MIT NUCLEAR REACTOR LABORATORY

Re: Massachusetts Institute of Technology; License No. R-37; Docket No. 50-20; Response to RAI (TAC No. MA 6084) dated 7/16/2010 and Other Related Information

Response to RAI Dated 07/16/10

**TECHNICAL SPECIFICATIONS
FOR THE MIT RESEARCH REACTOR (MITR-II)**

Figure 2.1-1 MITR-II Safety Limits for Forced Convection Operation

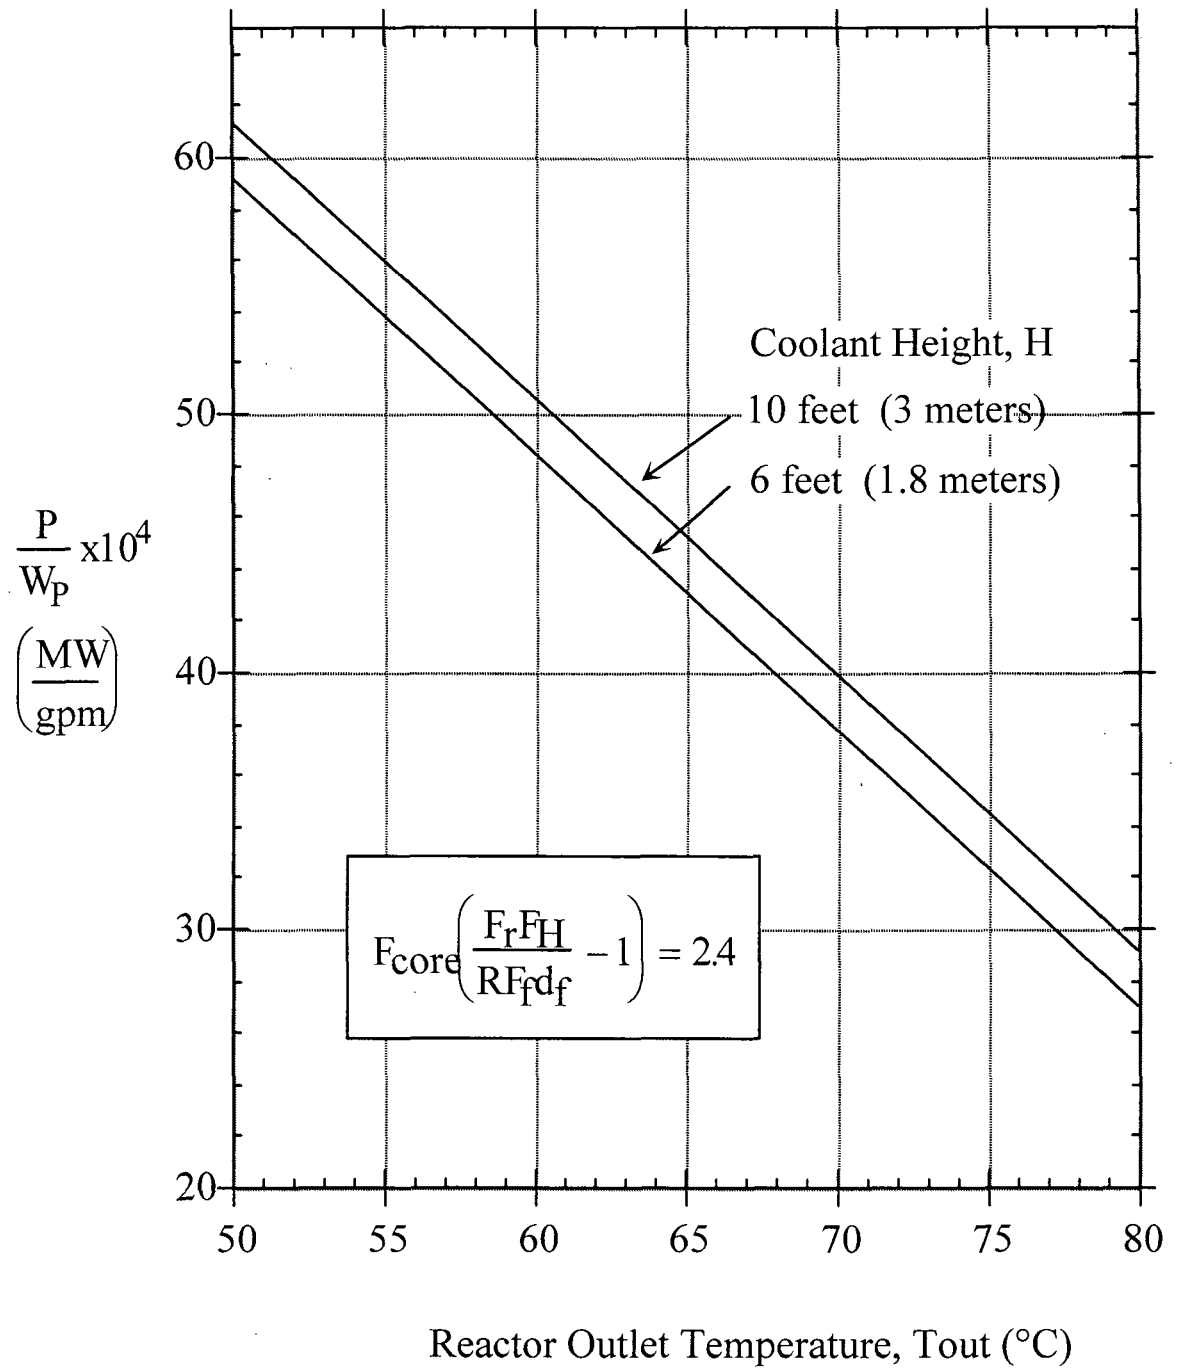
1.	Requested change made.
2.	Proposed TS 2.1.1 has been revised to include the fuel cladding temperature as a safety limit.
3.	<p>The third paragraph of the basis of TS 3.3.6 is changed to read:</p> <p>Electrical conductivity is also monitored to control purity of the primary coolant. A limit of 10 μS/cm is adopted because this limit has been observed for the MITR since 1974 and no corrosion issues have ever been identified with either the fuel or the core structural materials.</p> <p>A new fourth paragraph of the basis of TS 3.3.6 is added:</p> <p>The limits on the fuel storage pool water are those that have been observed for the MITR since 1974 and no corrosion issues have ever been identified with either the spent fuel or the storage pool tank.</p>

This specification also applies to the cladding temperature.

3. For transients described in Technical Specification No. 3.1.3, the fuel cladding temperature shall not exceed the cladding softening temperature (450 °C).

The safety limit for transients described in Technical Specification No. 3.1.3, "Maximum Safe Step Reactivity Addition" is the fuel cladding softening temperature (450 °C). For this type of transient, calculational models are used to determine the total energy produced and the associated temperature rise of the fuel. For a 2.3 beta (1.8% $\Delta K/K$) reactivity insertion over period of 0.5 s, the maximum fuel temperature is 83.4 °C [1].
